Submissions and Amendment Report

16-20 Old Castle Hill Road

SSD-85238209

Prepared by Colliers Urban Planning

Figure 2 Street frontage set back amendments

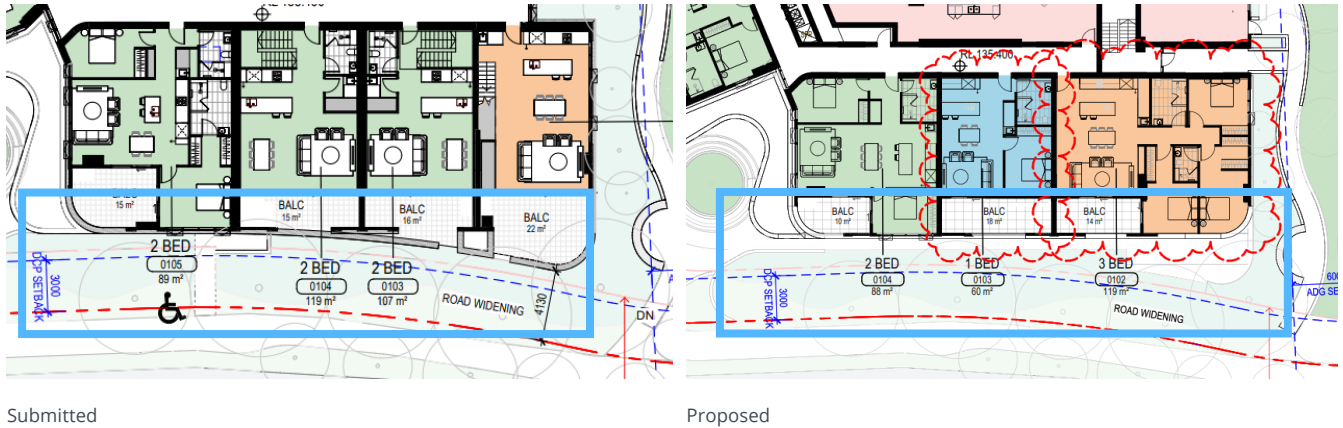
In response to concerns regarding future road widening along McMullen Avenue, the southern frontage of the building is proposed to be set back further from the boundary, in order to ensure that there is sufficient space for the front of this building to respond to a future widened road scenario, should that occur. This amendment is shown in **Figure 2**.

Figure 3 Revised excavation extent compared to the originally submitted design

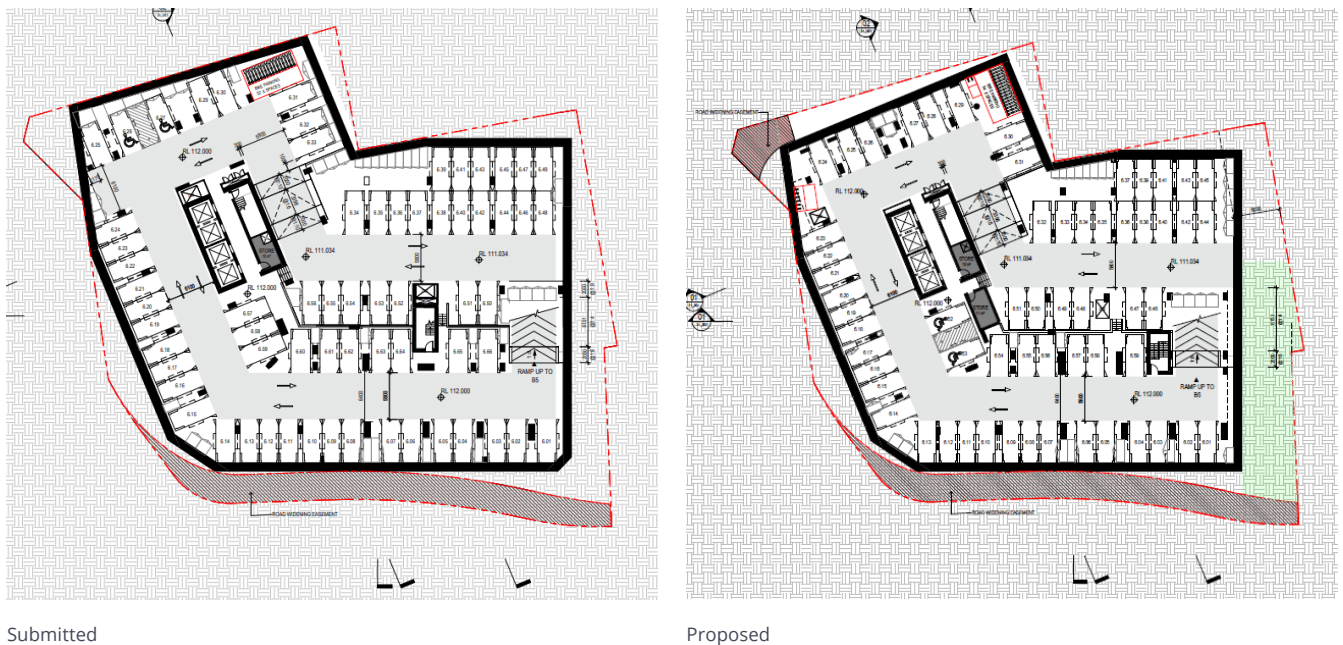
The basement extent has been recessed from Garthowen Crescent to accommodate the area required for future road widening, and reduced in its easterly extent to provide for an improved deep soil outcome. The deep soil amount now achieves the ADG design criteria of 15%.

A comparison between the original basement layout and the proposed revised extent is provided in **Figure 3**.

Figure 4 Proposed bike storage on Ground Floor

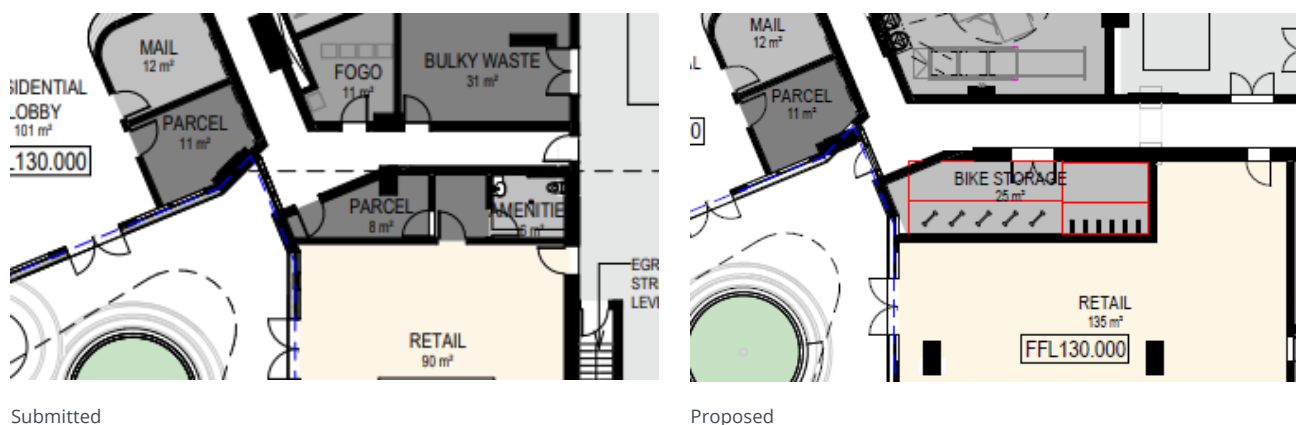
Bicycle parking has been increased from 160 to 179 spaces to improve support for active transport use for residents. Bicycle parking is now provided on the Ground Floor with direct and step-free access from the street (**Figure 4**). A comparative table has been provided below in **Table 3**.

Figure 8 Comparison of submitted and proposed entry

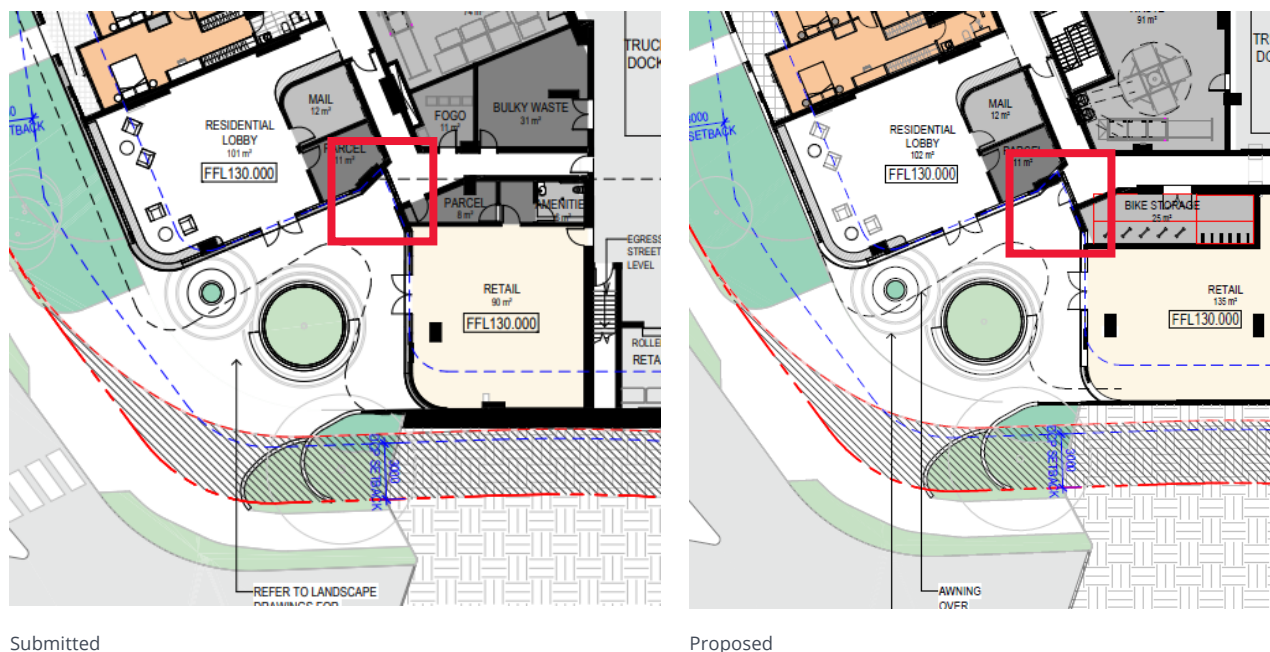
The resident entry point from the public domain has been refined to improve its clarity and legibility from the street. The previous entry, which had a triangular form, has been redesigned with a straightened alignment to provide a more prominent arrival point with improved sightlines for residents.

Refer to **Figure 8** below.

Figure 10 Comparison of submitted and proposed external finishes and materials

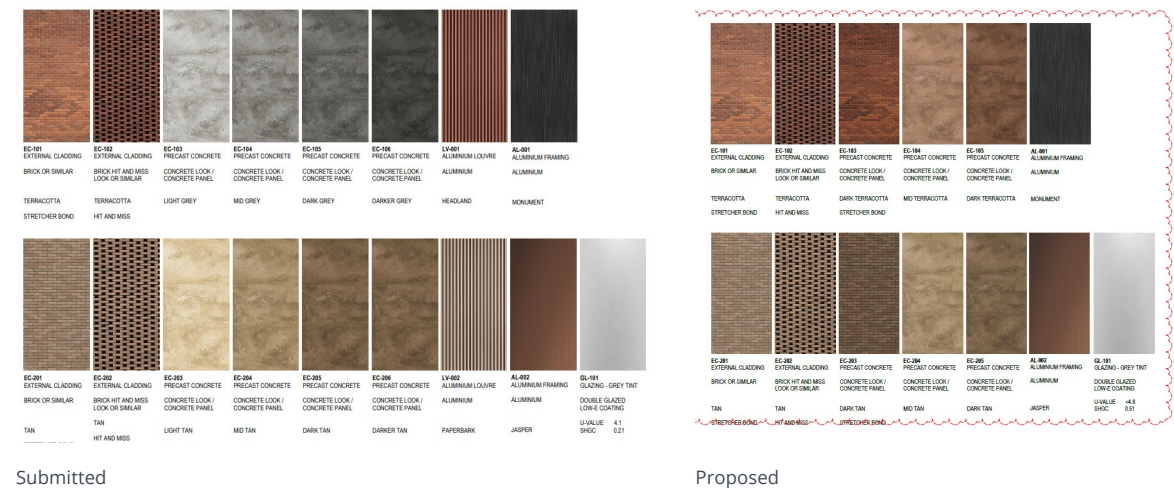
The façade colour palette has been revised to incorporate a natural, earthy range of tones that responds to and integrates with the surrounding local context. Refer to a comparison of the submitted colour palette and the proposed palette in **Figure 10**.

The primary framing has been revised from a continuous vertical pattern to structured grid, improving the look and feel of the buildings by breaking up the extent of the building and providing visual relief through the tower. Additional façade elements have been introduced to provide greater depth and visual interest, while the infill pattern has been updated to create a more unified design and reduce the perceived bulk of the tower. The façade has also been refined to incorporate shading and recessed elements that improve solar performance. Refer to **Figure 11** and **Figure 13** below.

Figure 14 *Proposed development in existing and future context of locality*

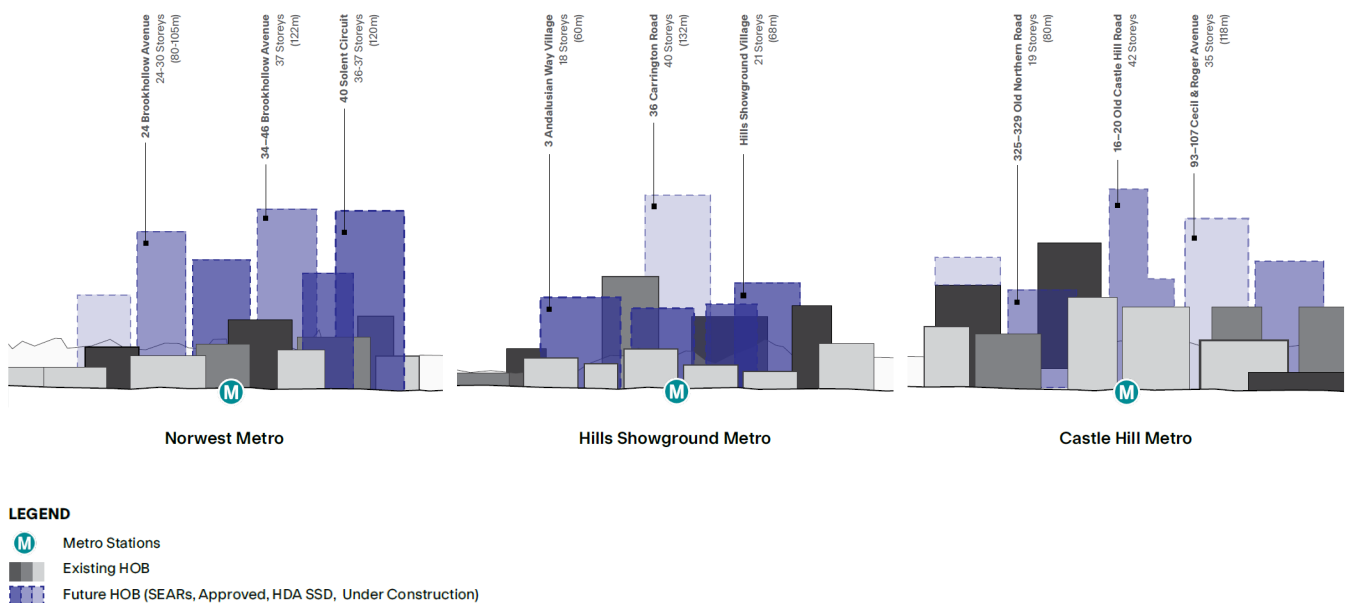
The slender high-rise portion of the tower has been amended to increase by two storeys, with its maximum height rising from the originally proposed RL 261.500 (131.1 m) to RL 267.800 (137.4 m), representing an overall increase of 6.3m. As a result, the tower height has increased from 40 to 42 storeys.

The minor increase in height will not be overly perceptible compared to the 40 storey proposal as lodged, generally appearing of similar scale, and from a planning hierarchy perspective, it will remain to sit comfortably in its context in the Castle Hill skyline, and in the context of the hierarchy of heights across key centres in the Hills Shire, as shown **Figure 14** below, which shows the proposal in the existing and future context.
